Errata Sheet

Rel. 1.1, 15.12.2006

Device	**XC866-1FR**
Marking/Step	**EES-AA,ES-AA**
Package	**PG-TSSOP-38**

Figure 1 Critical Cases for Power up/ Power down when $V_{residual}$ >500mV

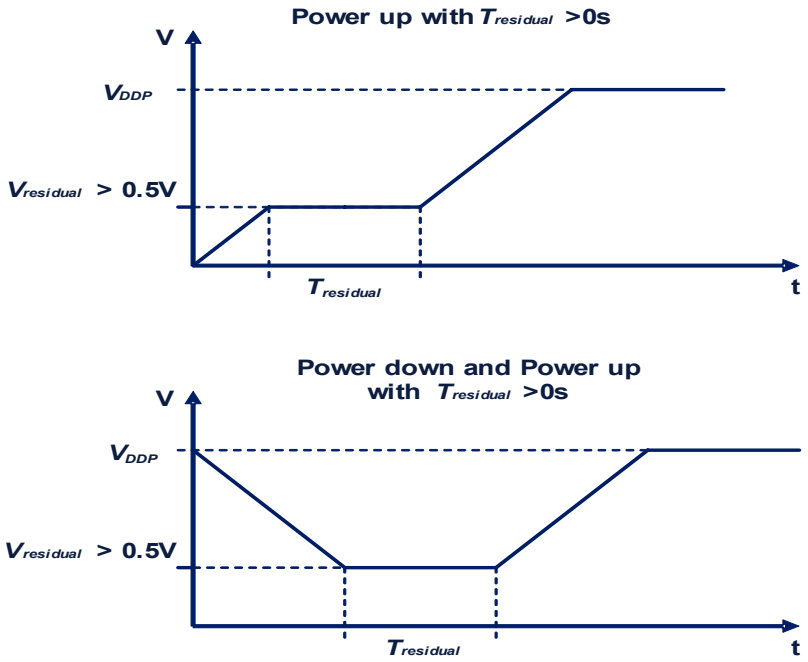
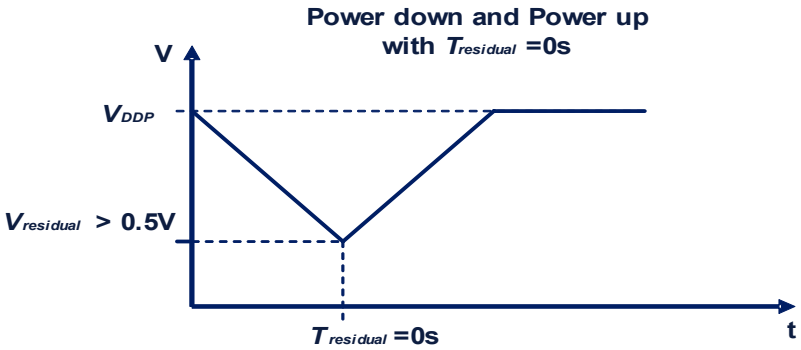
EVR_XC8.005 Reset toggling issue for repeated power up

Due to the limitation of the EVR, the reset toggling may occur during the power up. To prevent the reset toggling issue for power up, the following conditions must be met :

1. For power up, the rising time must be less than 2ms/V.
2. The power down time must be more than 0.2ms/V.
3. A permanent V_{DDP} residual voltage is less than 500mV.

In case of V_{DDP} residual voltage is more than 500mV, the holding time of residal voltage affects the reset toggling issue. **Figure 1** shows the critical cases for power up/power down when the residual voltages is held for some time. **Figure 2** shows the uncritical case for power up and power down when the power up is triggered immediately after power down. In case of a residual voltage due to immediate power up after power down, the users have to contact IFX to ensure no power up failure.

None.

Figure 3

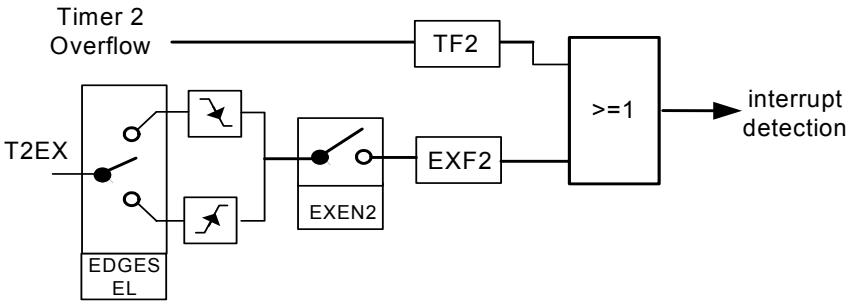
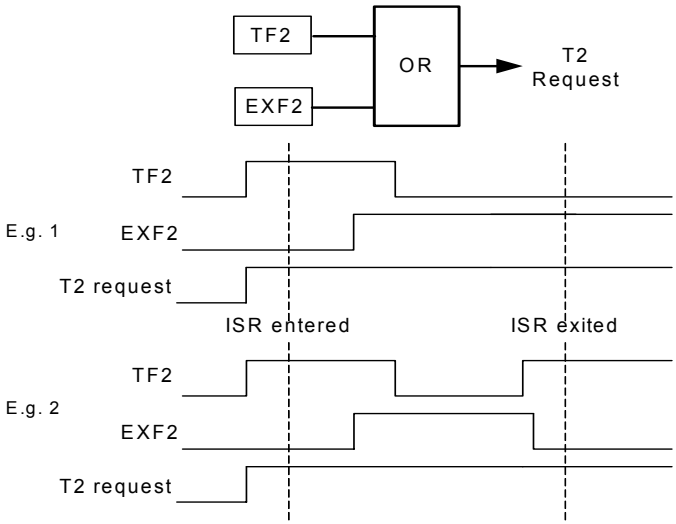
INT_XC8.004 Unable to Detect New Interrupt Request if Any One of Timer 2 Interrupt Flags Is Not Cleared (Unexpectedly)

As illustrated in the simplified figure, the Timer 2 interrupt flags TF2 and EXF2 are combined as one interrupt request output. These flags are located within the Timer 2 kernel, with a single interrupt request line as output from the kernel.

Being of interrupt structure 2, the interrupt request of Timer 2 is detected on the rising edge of a positive pulse.

The problem is that it may occur at some point in the application, that any new Timer 2 interrupt request can no longer be detected after a return-from-interrupt (reti) due to service of earlier event(s). This happens when the following conditions are true:

1. Timer 2 events are serviced by interrupt (i.e. flags are checked and cleared only in the interrupt routine ISR),
2. Either TF2 or EXF2 is set at any one time throughout the ISR (even while the other is cleared) such that at least one of the flags is still set after reti, causing the Timer 2 request line, which is an OR-function of the two flags TF2 and EXF2, to remain set throughout the ISR and after reti.

Two example scenarios are illustrated in the following figure:

This means, any future Timer 2 TF2 or EXF2 event is not able to cause a rising edge and therefore not able to trigger an interrupt request to the core – as if the Timer 2 interrupts had been disabled, until both EXF2 and TF2 flags are cleared at some time. The clearing of flags would have to be done by user's code additionally outside of the Timer 2 interrupt routine, which is however normally not feasible with an interrupt service scheme.

There is no problem if EXF2 is not enabled by setting bit EXEN2 = 0 i.e. external events are disabled, or if bit DCEN = 1 in auto-reload mode.

Otherwise if EXF2 is enabled, while TF2 is always enabled when Timer 2 is running, there are two suggested workaround:

1. If other events of Timer 2 interrupt node (ET2) need not be enabled for interrupt, disable this interrupt node and use software polling of the flags instead.
2. Before return from interrupt, check again if TF2 or EXF2 is (still) set (due to new request since the last check). If so, jump and execute the ISR routine from start. Exit only when all flags are checked to be cleared. However, dummy interrupt of the node may occur after return from interrupt, and should be ignored. Another drawback is if Timer 2 events are occurring at high rate, the CPU may be 'stuck' in the service routine of the Timer 2 interrupt for a long time.

```
<entry point of interrupt node service routine>
.....
Start:
check flag TF2
.....
clear flag TF2
.....
check flag EXF2
.....
clear flag EXF2
.....
Finish:
if TF2 or EXF2 is set, jump to Start
reti (return from interrupt)
```

Figure 6

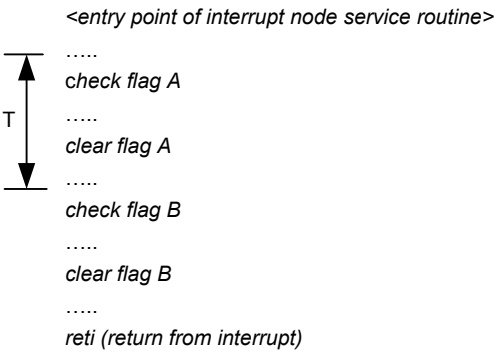
INT_XC8.H001 Interrupt Request With No Interrupt Flag Set

It might occur in the application, that sometimes interrupt requests are serviced, but no active interrupt flags are found. This would happen for those interrupt nodes which is shared by several interrupt sources.

Consider the following interrupt service routine pseudo-code, and scenerio where a interrupt source A event leads to interrupt request of the node and CPU vectors to the interrupt routine. Meanwhile, interrupt source B and its flag becomes active any time in the duration indicated by T:

In this case, flag B will be cleared as a standard procedure by the interrupt routine in the current service of the interrupt node. However, the pending interrupt request for the node remains activated after RETI, as it is only cleared by hardware when CPU acknowledge the interrupt and vectors to the interrupt routine.

This leads to following servicing of the interrupt node again, but potentially no active flag is found, i.e. dummy interrupt service. The point to note is that the interrupt source B is not lost, as it was actually serviced in the current service of the interrupt node.

The recommendation is to ignore these dummy interrupt vectoring.

Figure 7

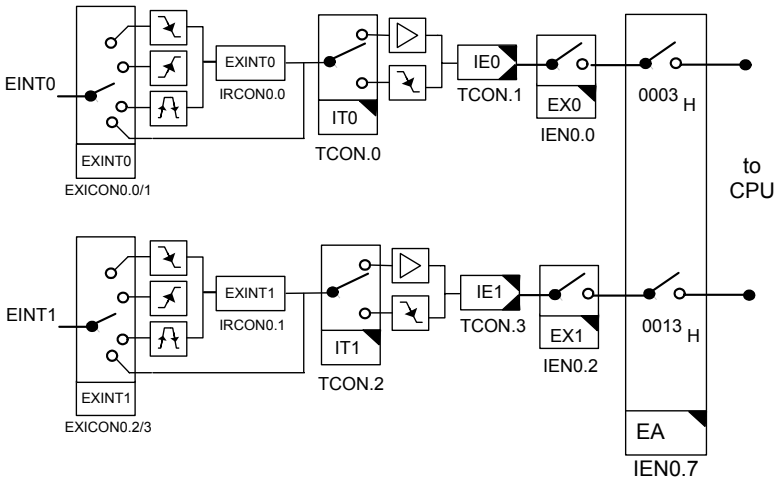
INT_XC8.H003 Interrupt Flags of External Interrupt 0 and 1

External interrupt 0 and 1 may individually be selected via respective bits (EXINTx) in EXICON0 register, to request interrupt on falling edge, rising edge, both edges or to bypass the edge detection.

Edge detection is done in the system unit. If enabled, an active event will set the EXINTx flag and correspondingly set the IEx flag in TCON. It should be noted that after any external interrupt x event, flag EXINTx must be cleared. In case of falling edge as active event, this allows any future active event to be able to set the flag IEx as interrupt request. In case of low level as active event, this prevents unintended recurring triggering of interrupt request.

In case of bypass edge detection, the input is connected directly to the core (bypass the system unit). The flag IEx in TCON will be set on the selected falling edge or low level (at least 2 clock cycles) event. In case of falling edge selected as active event by TCON.ITx, the flag EXINTx is set in addition to the flag IEx. However to use this mode properly, user must not clear the flag EXINTx and if necessary, to only access the flag TCON.IEx (refer to INT_XC8.003).

1. Flag IEx is cleared automatically by hardware when the interrupt is being vectored to.
2. Flag EXINTx has to be cleared by software.
3. Clearing one external interrupt x flag will not clear the other. Especially, clearing flag EXINTx will not clear the flag IEx. Being of interrupt structure 1, the flag IEx is the request polled by the CPU for interrupt servicing. Therefore user has to take care to clear the flag IEx before switching from SW polling method to enabling the external interrupt x node, to prevent potential dummy interrupt request.
4. Always clear both EXINTx and IEx flags before (if) changing the trigger select in EXICON0 register.
